# **LiDAR Quality Assessment Report**

Materials Received: 3/14/2013	Project Type: Donated Data
Project ID: MO_Monroe-Audrain- MontgomeryCos_2011 Project Alias(es): MO_Grand_2011	Project Description: Monroe, Audrain, and Montgomery Counties are part of the Missouri Grand 2011 LiDAR dataset. The St. Louis District of the United States Army Corps of Engineers (USACE) contracted with Surdex Corporation in the fall of 2011 to collect high resolution LiDAR elevation data over multiple counties as part of the Missouri Grand Counties Lidar Project. This project consists of 4 delivery blocks including all or part of Howard, Cooper, Montgomery, Livingston, Randolph, Monroe, Audrain, Lincoln, Macon, Adair, Sullivan, Putnam, and St. Louis City and County. There is additional coverage within Ray, Gasconade, St. Francois and Jackson Counties. The project combines the varied interests of the NRCS, USGS, USACE and State Emergency Management Agency (SEMA) totaling over 6287 square miles into a unified collection and processing project to benefit the US Government. The NRCS shall serve as the technical point of contact with the USACE St Louis District.

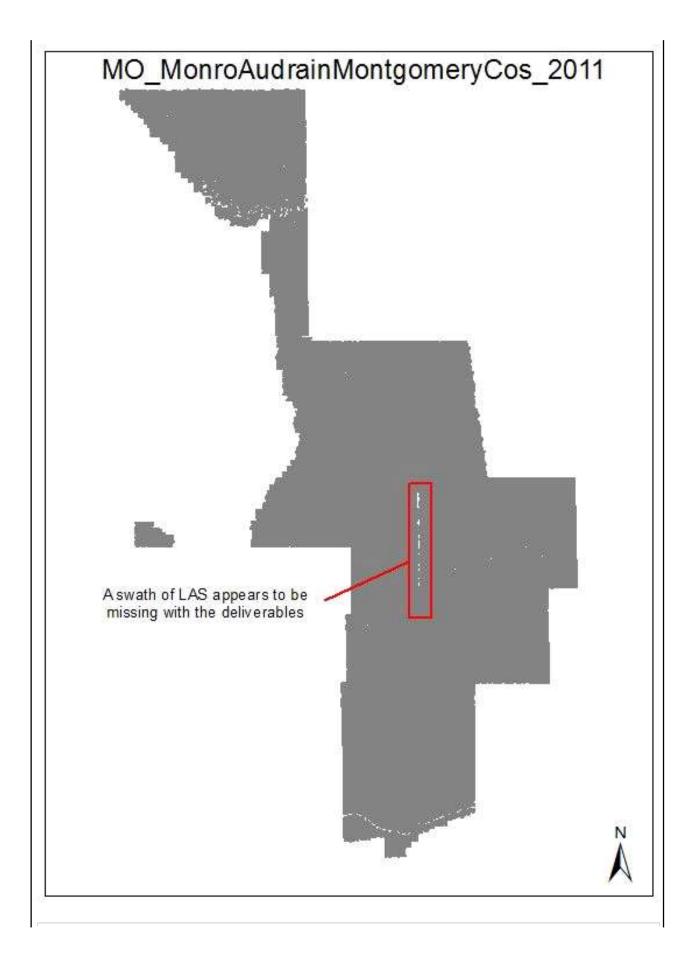
Swath LAS file LDR111208\_143323\_1 is missing points. The project is recommended for the NED, however, the swath LAS is rejected due to missing points. An image of this error can be viewed above - in the LAS Swath File Review section of this report.

\*\*This tile had been replaced by contractor - T Jerris 6/10/2012

\*\*6/10/2013 Swath LAS file LDR111208\_143323\_1 has been resubmitted, verified by NGTOC, and accepted.

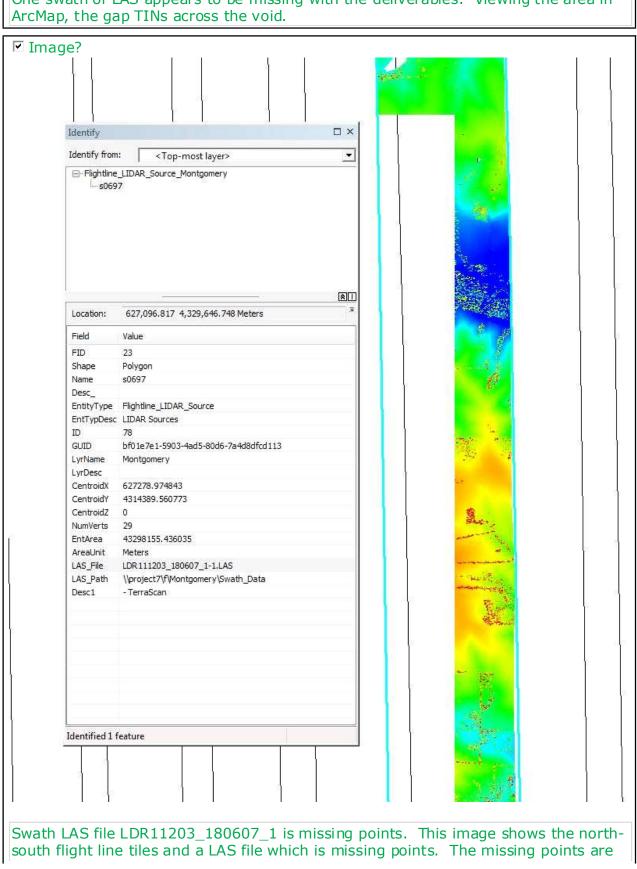
Larger Properties General Source Surbology Display Performance ( Date Source LAS Files Extent	btoms	
Top 4390969.06	ZMin: 129.657	
East 564000.58 Hight 65 Bottom: 4278453.25	2Max: 245.280	
Current Coordinates System	67106 647.000	
	Impol. Modig. New Clear	
Swath LAS reads "Unk	nown Coordinat	e System".
**Error corrected by c	ontractor (5/31	/2013).
Image?

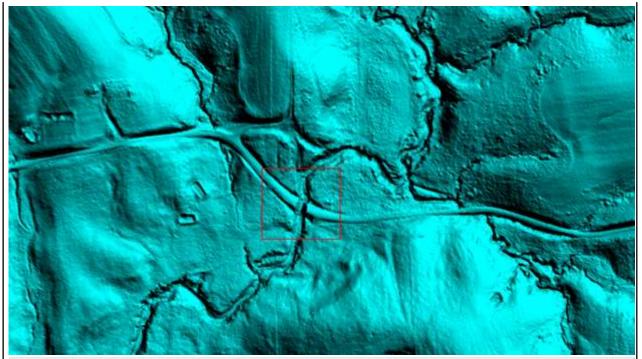
culvert\_1: This is a representative image of the error-type 'culvert', whereas the roadway was removed above a waterbody (stream). Roadways above culverts should not be removed. 104 culvert-errors have been identified within this dataset.

\*\*These errors have been corrected by the contractor (5/31/2013).

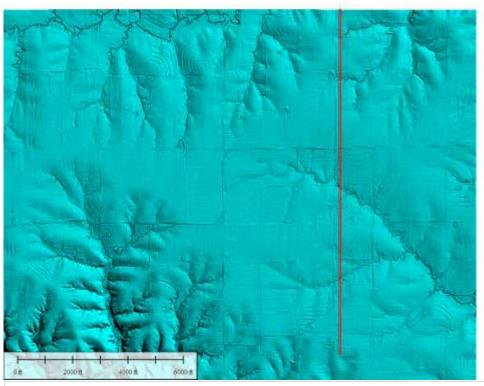
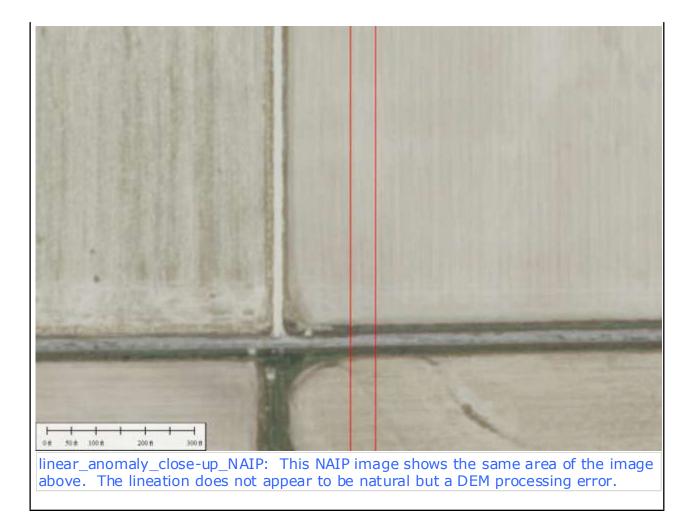
linear\_anomaly: The area in red shows the extent of a north-south trending anomaly within the DEM. The image below shows in detail this lineation. There are two of this error-type. Both errors follow the same longitude.

\*\*These errors have been corrected by the contractor (5/31/2013).
